September 26, 2024

Reference: Engineering Services  
Permit # SFD2209-0009  
891 Raynor Road  
Spring Lake, NC 28390  
TE&D Project No.: 2401-020836

### Footing Repair

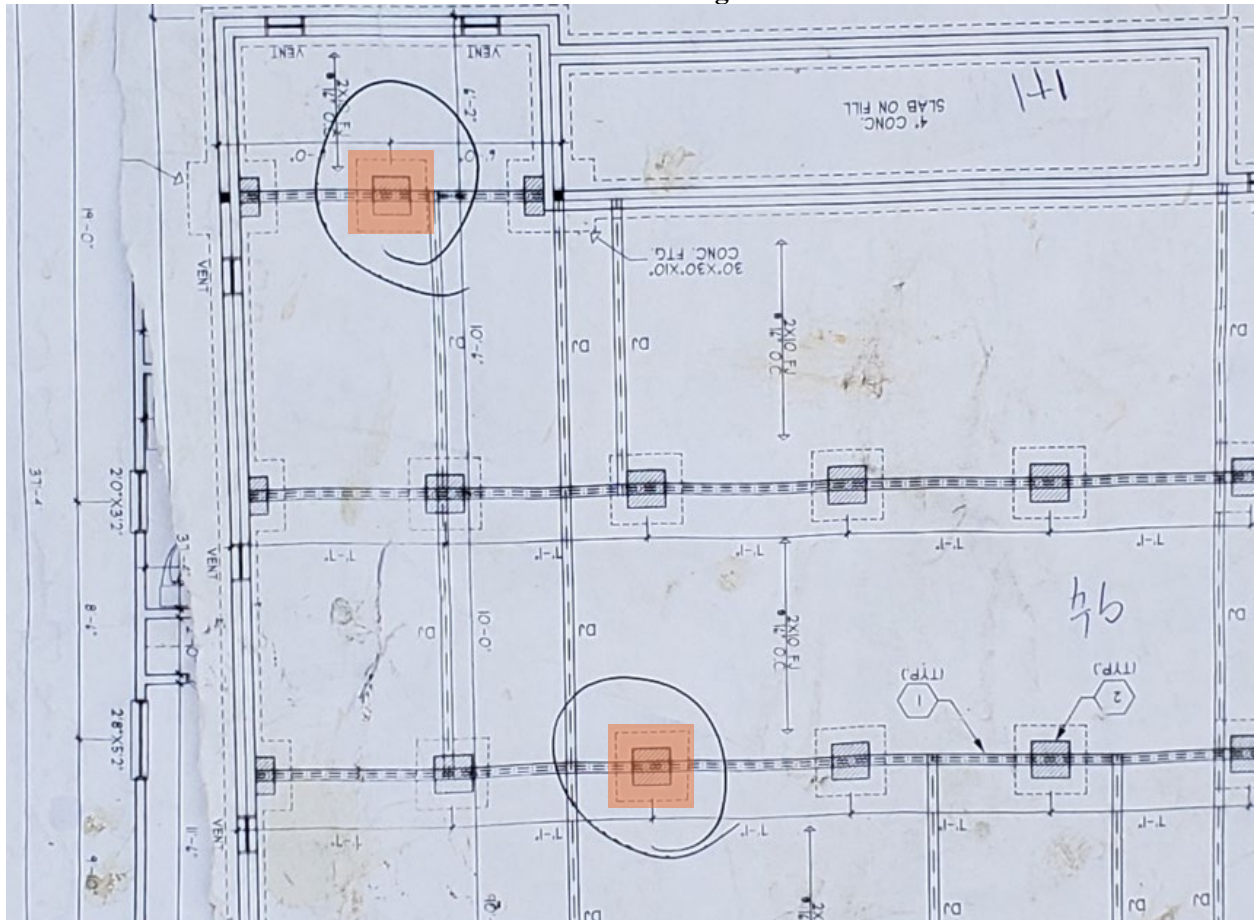
- 1) Based on our observations and analysis, the footing is to be repaired per the detail on page 3 of this report. Upon completion, the newly added sections of concrete will provide the required support for the anticipated loading conditions.
